## SITE PLAN REVIEW

Project Name: STORAGE UNITS

FILE #SPR-95-128

TITLE HEADING: Site Plan Review - Storage Units

SU DESIGN VEHICLE

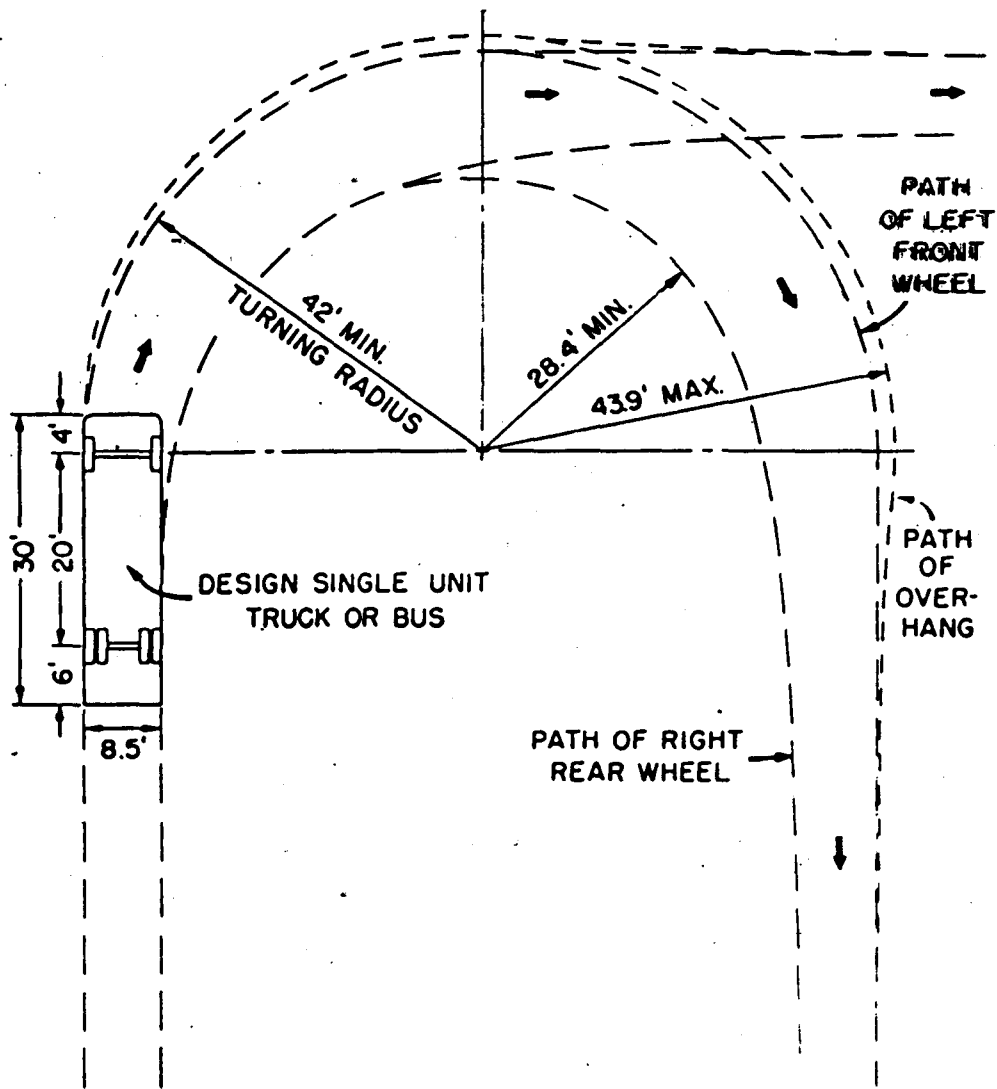
1. The plan does not allow for adequate circulation. The only way for vehicles to exit this site is to back all the way out from the rear of the site. The separation between the buildings is not wide enough to allow vehicles to maneuver. Enclosed is a copy of a turning template for a single unit vehicle, representative of a U-Haul type truck. Please use it to design the site so that vehicles can maneuver adequately. The site plan does not indicate where the doors of the storage units will be located. Please provide a building elevation to assist in this determination.

# Hill and Holmes Storage

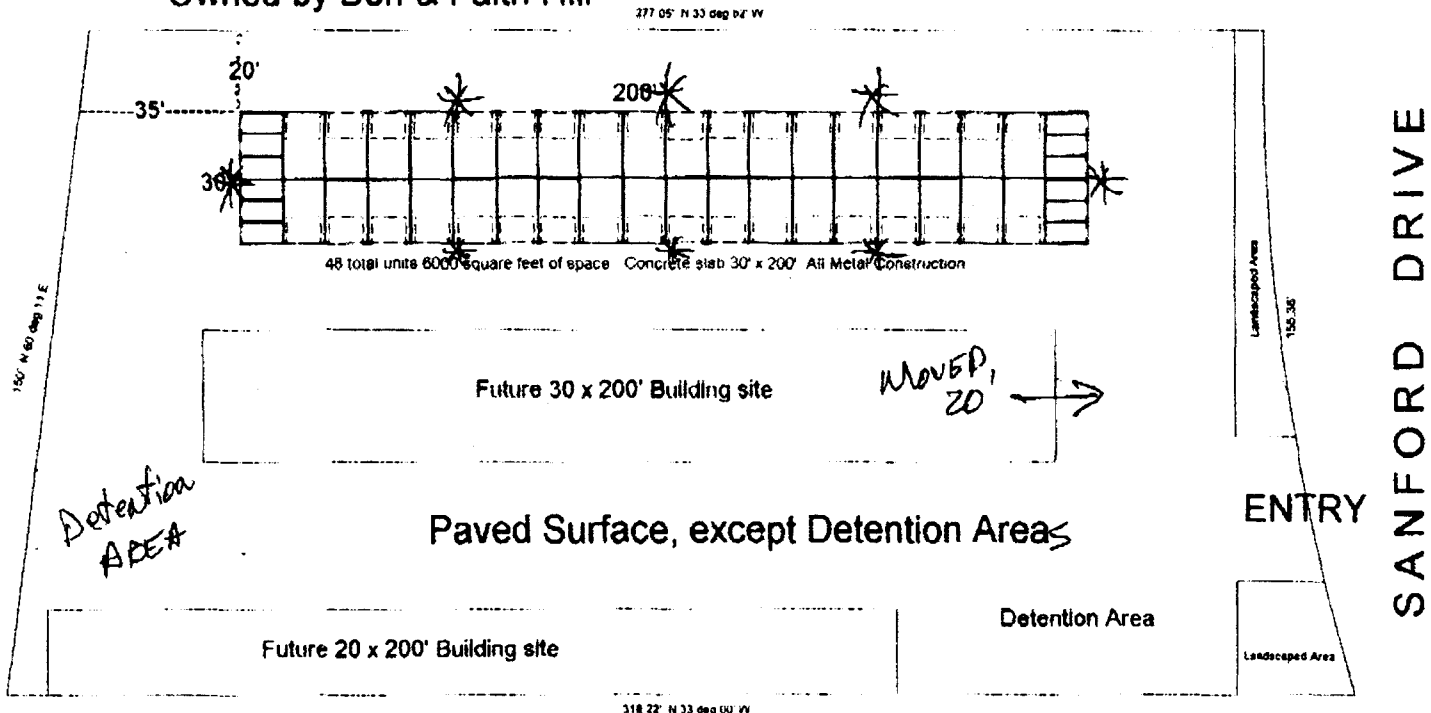
1. See Development Engineer's comments regarding circulation; this Department shares the same concerns. We recommend that landscape areas on the Sanford Drive frontage be narrowed and lengthened (area may remain the same) to better define the driveways.

2. Rear of lot abuts highway frontage and also has the same landscaping requirement as the Sanford Drive frontage. We would recommend that you consider a row of trees (spaced no greater than one tree per 30 ft.) rather than the shrub area.

3. No fence is shown on the plans. Will there be fencing on the site? If so, please indicate on plans.
4. Project narrative indicates that one storage building is to be built at present with the remaining buildings in the future. Please indicate your phasing on the plans including the extent of the improvements (e.g. paving, drainage facilities, etc.) to be constructed with the first phase. Approval of this project will only require a Planning Clearance for future phases as long as the plans remain the same.

- \* = photo cell lights
  - Fenced entire perimeter 6' w 1" B-wire
  - GATE will be 20' minimum
  - Trees will be planted every 30' on STATE SIDE
  - 48 units phase 1. - 122 TOTAL
- 7/28/95 Ben Hill

1. Landscaping along rear property line must be provided - one shade tree per 30 feet of frontage.
2. Landscape areas in front shall be narrowed and lengthened to better define the driveway (as per attached drawing).
3. Proposed fence must be shown on plans.
4. Proposed phasing of improvements must be shown on plans. In Phase I, the following must be constructed AT A MINIMUM: (a) asphalt pavement at least 20 feet wide around the building and an asphalt driveway between the building and the street; (b) the landscaping (both frontages) on the east (Phase I) side of the site; (c) the drainage facilities; (d) site fencing; (e) lighting on building.
5. Indicate proposed lighting on plans.
6. Revise future building locations as per attached drawing.
7. Indicate number of units proposed in each building.
